Re: Christina Kent Day Care
205 COAL AVE SW
Traffic Circulation Layout
Engineer's Stamp Dated 1-14-25 (K14D234)

CHRISTINA KENT DAY CARE

SOLID
WASTE
PLAN

A1 TRAFFIC CIRCULATION LAYOUT

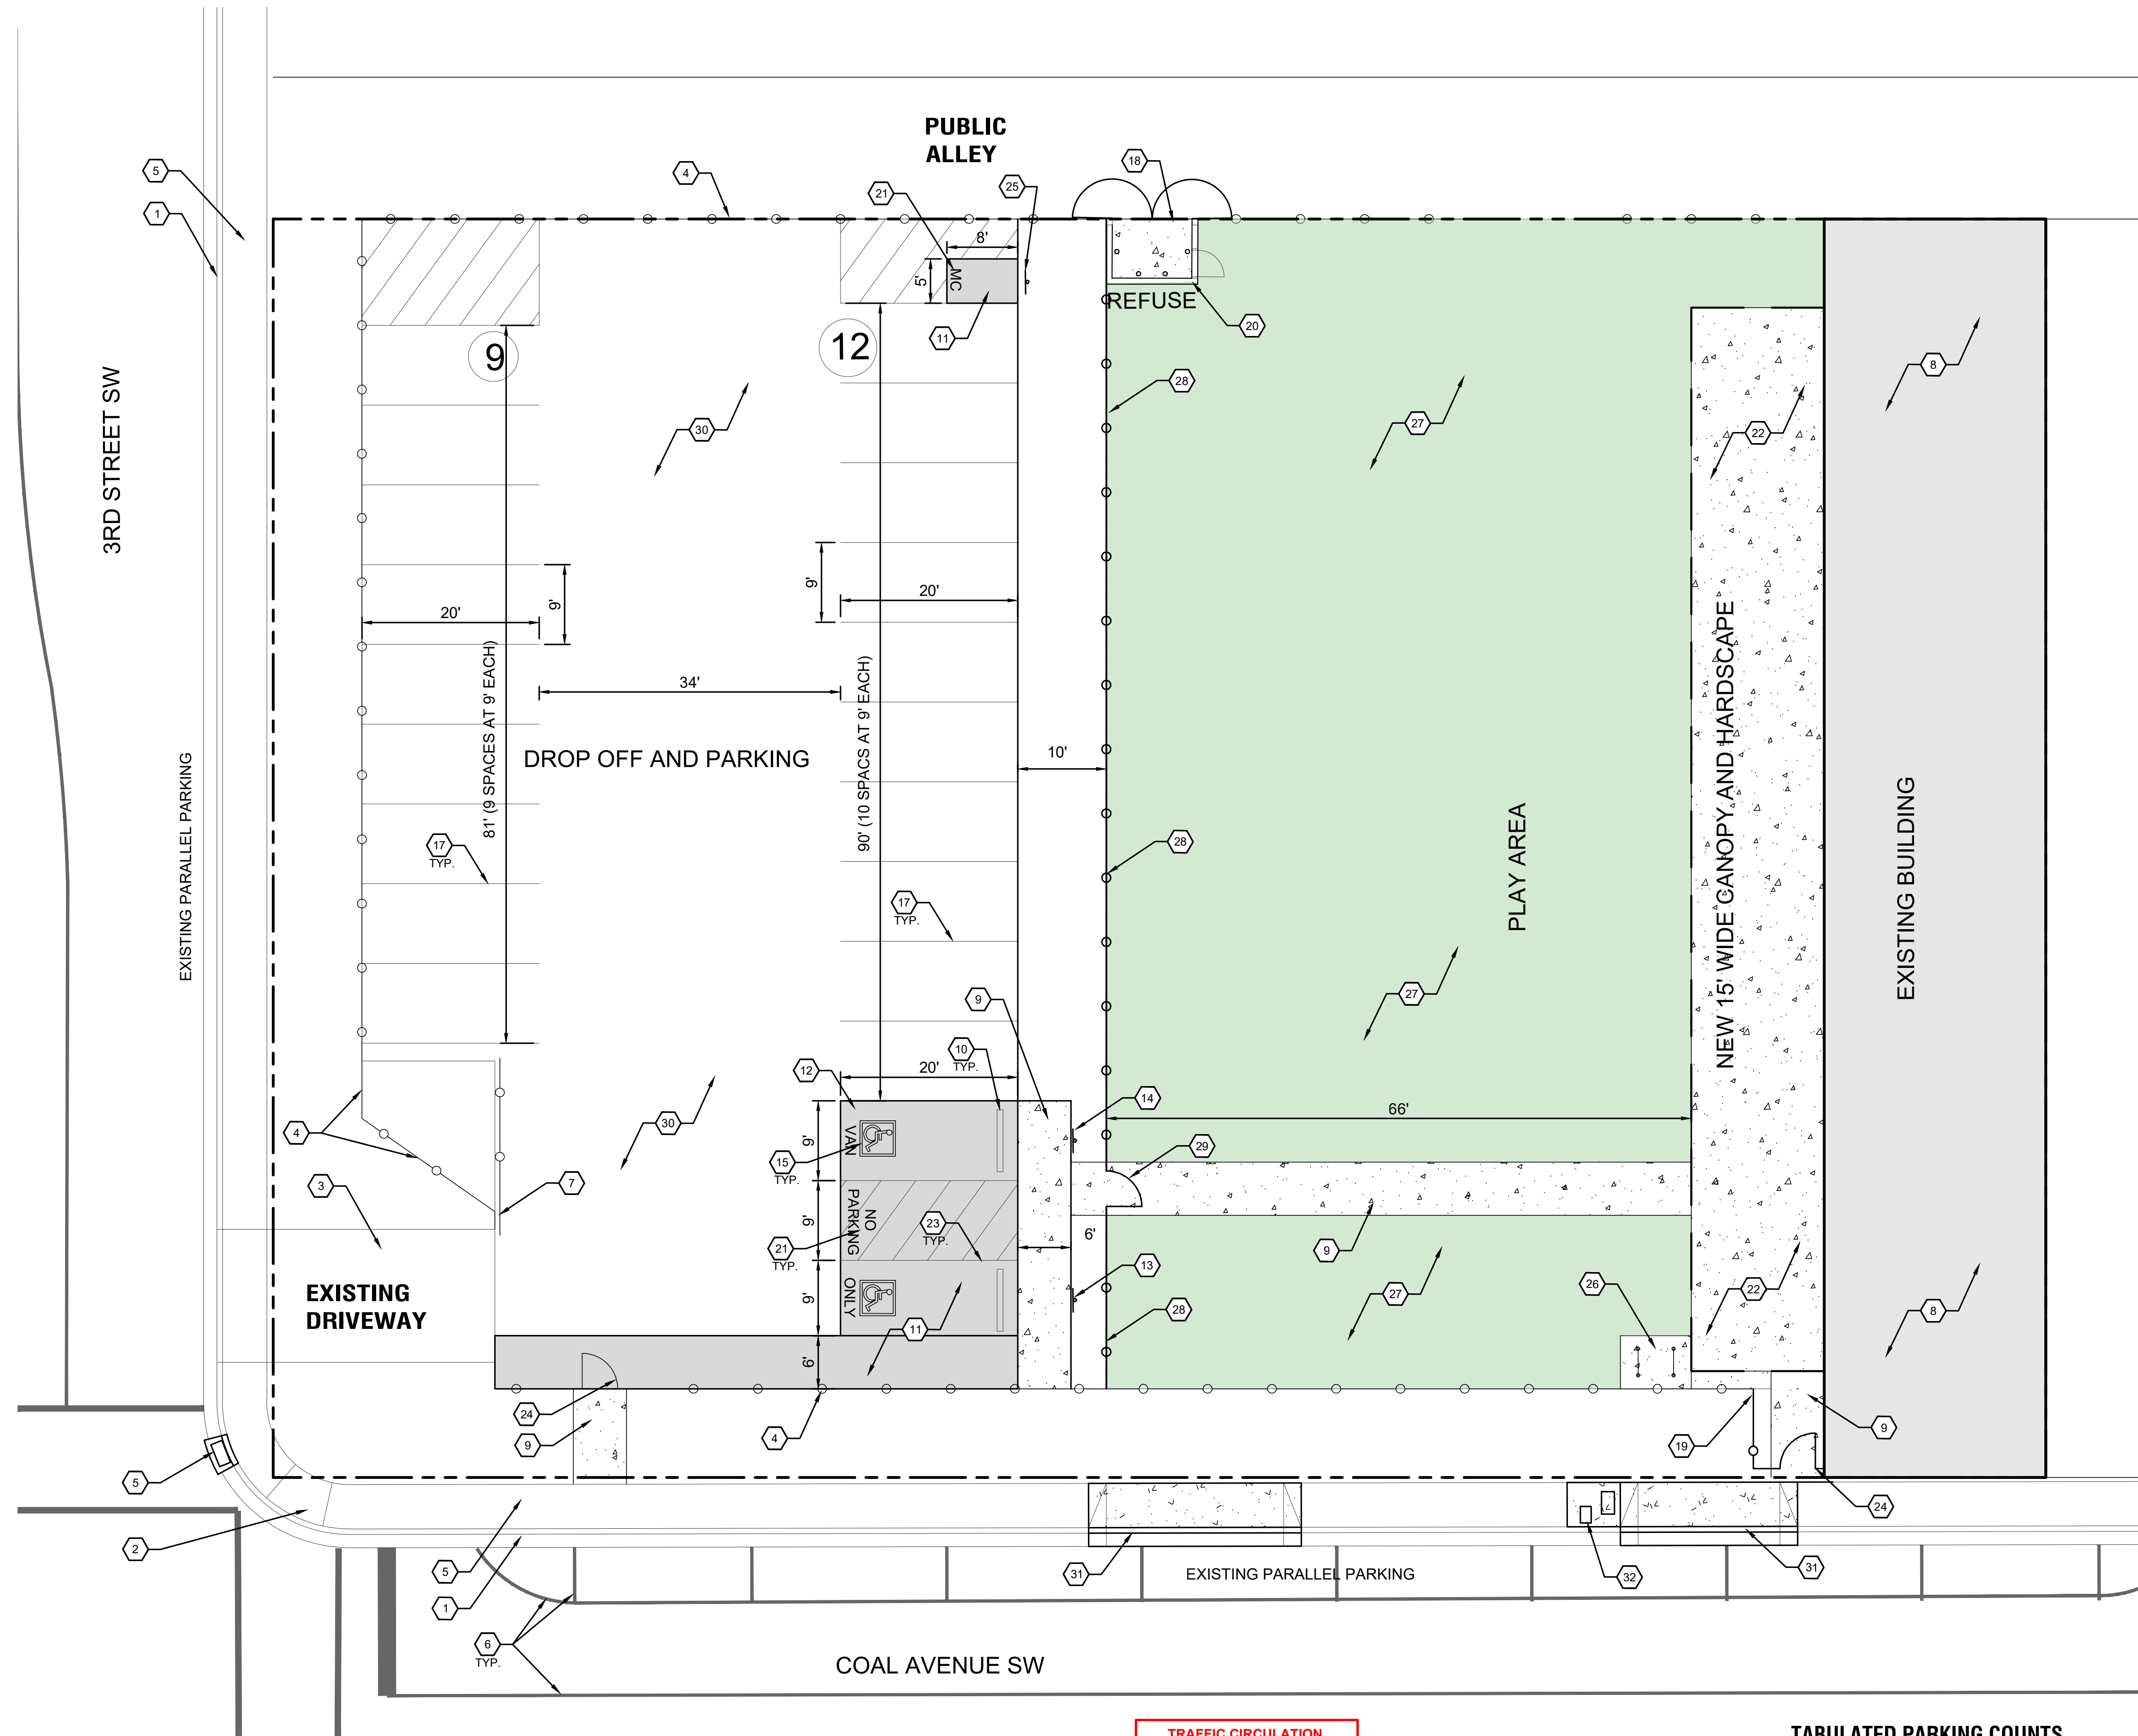
The TCL submittal received 1-16-2025 is approved for Building Permit by Transportation. A copy of the stamped and signed plan will be needed for each of the building permit plans. Please keep the original to be used for certification of the site for final C.O. for Transportation.

A1 SOLID WASTE PLAN
SCALE: 1" = 20'-0"

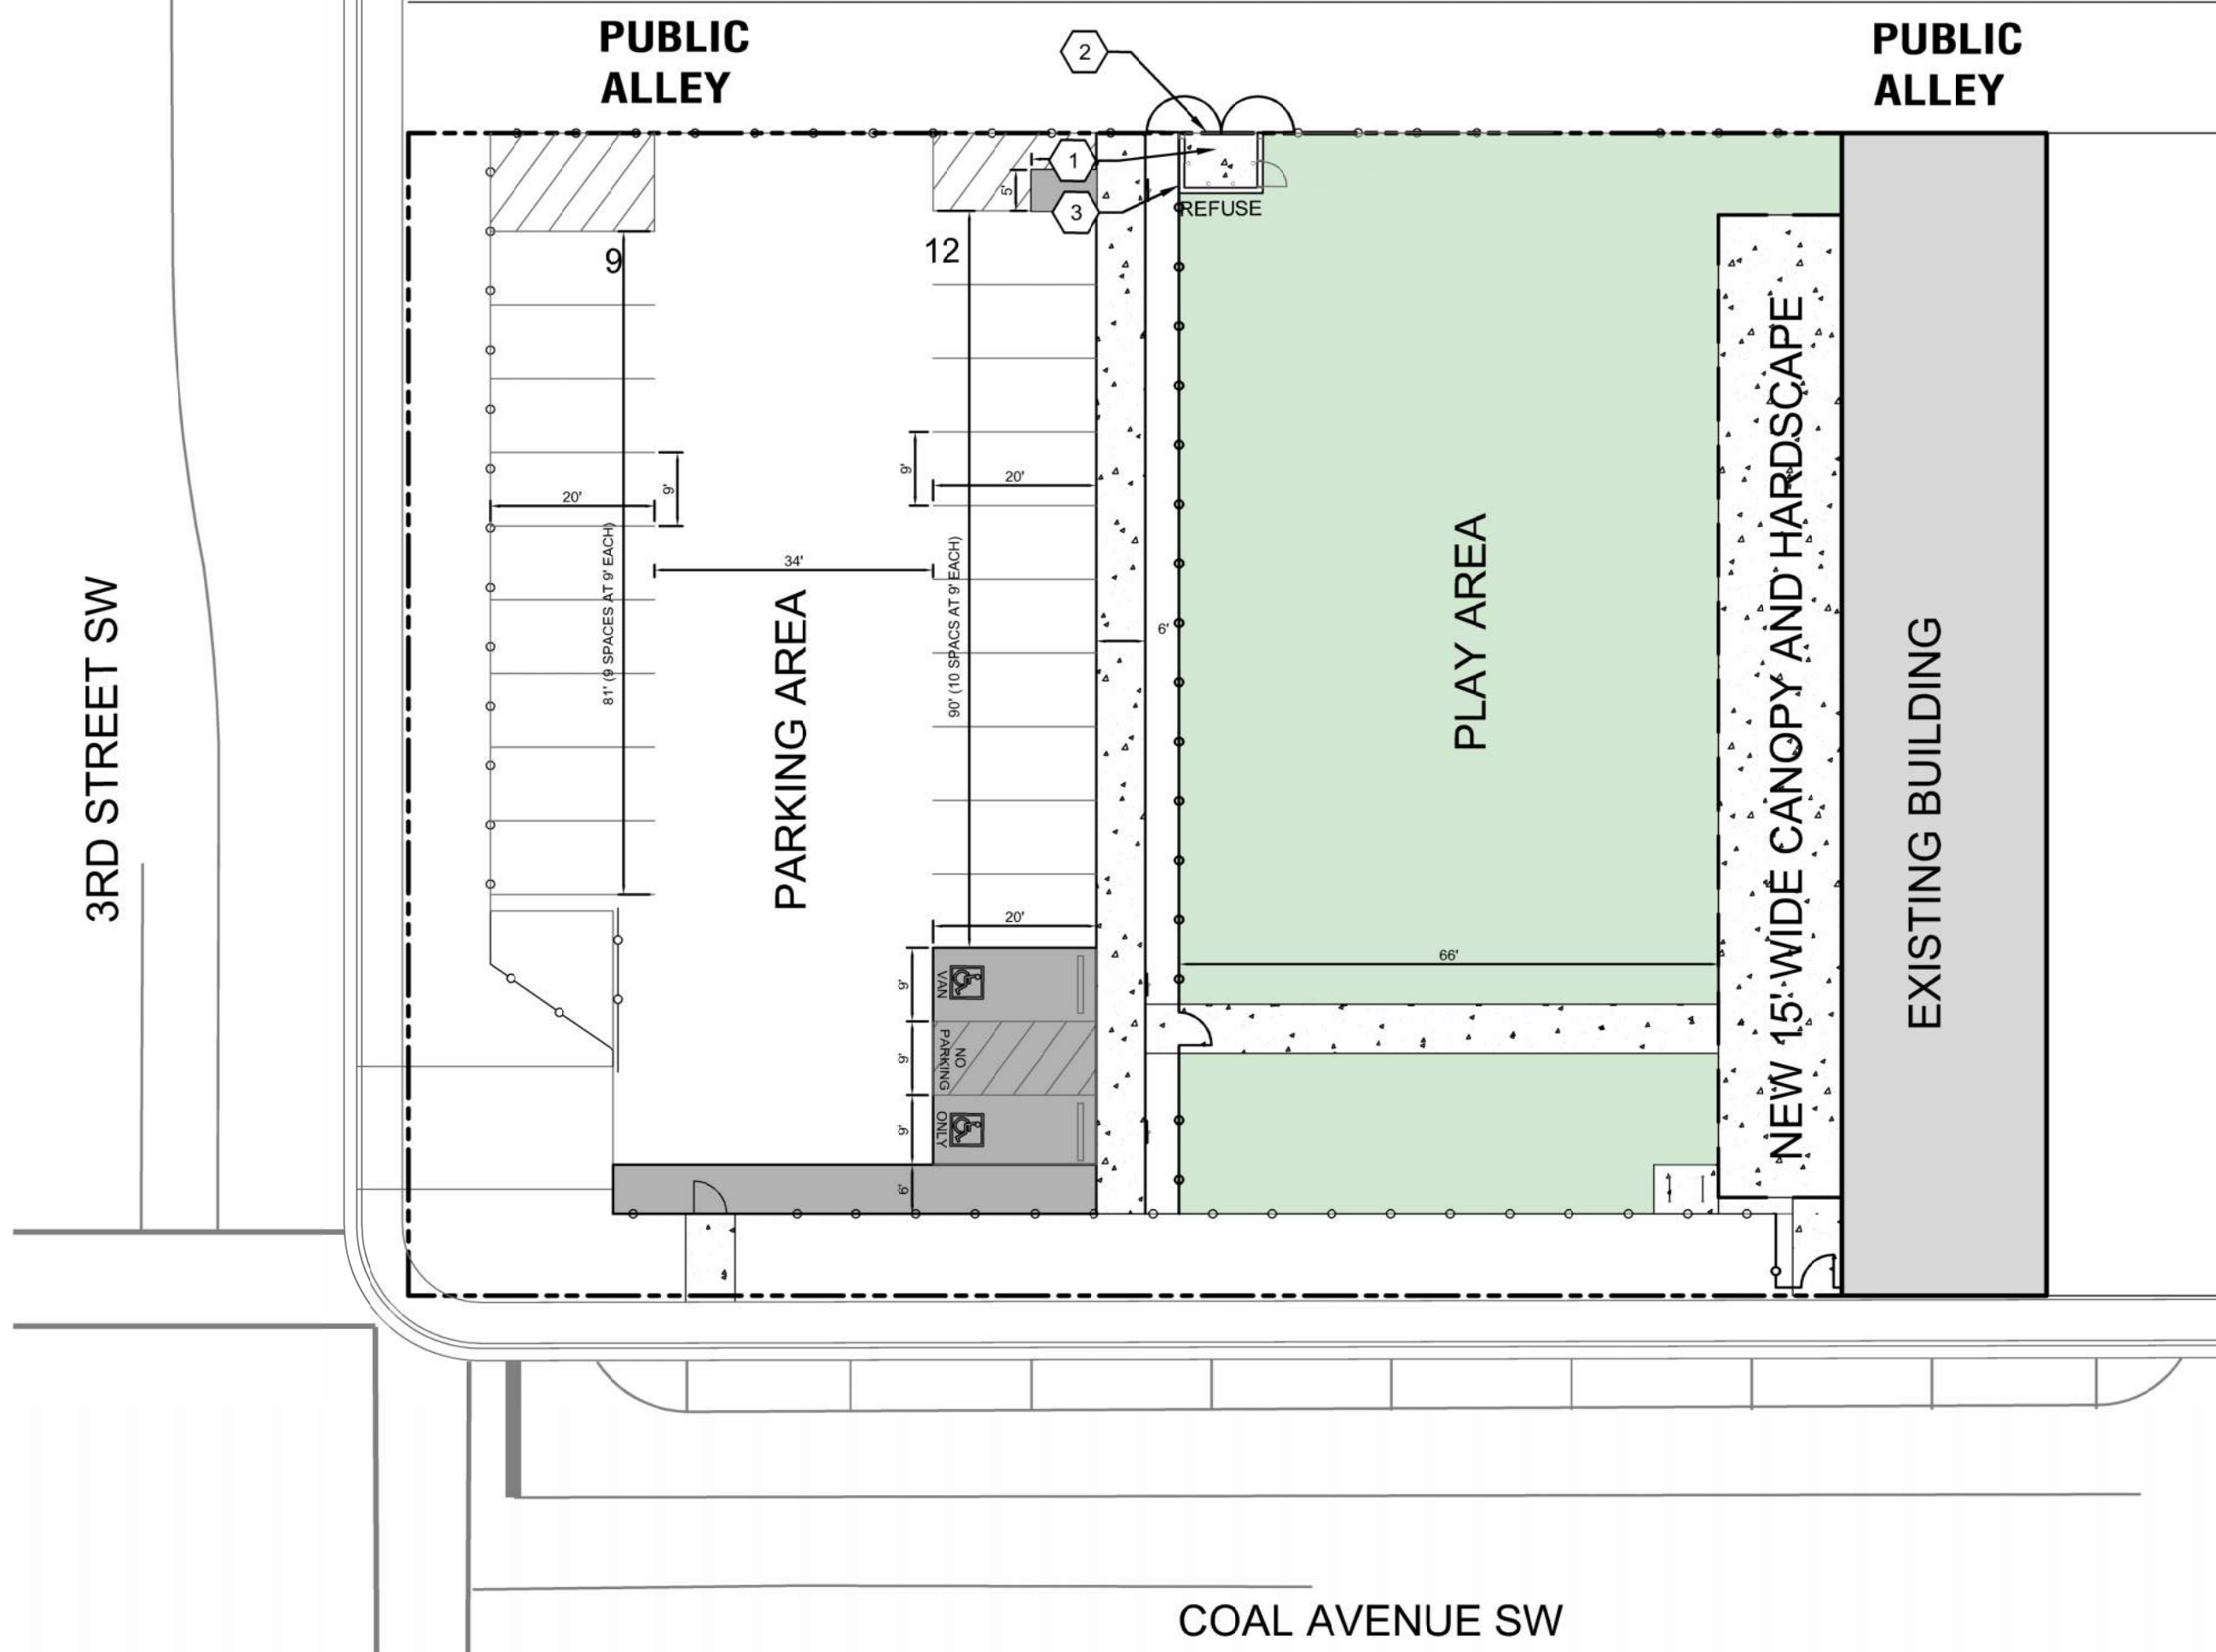
Approved for access by the Solid Waste Department.

All containers must be made accessible for pick up

between the hours of 5AM and 8PM.

****Recycle Declined****

****Swanson Service****
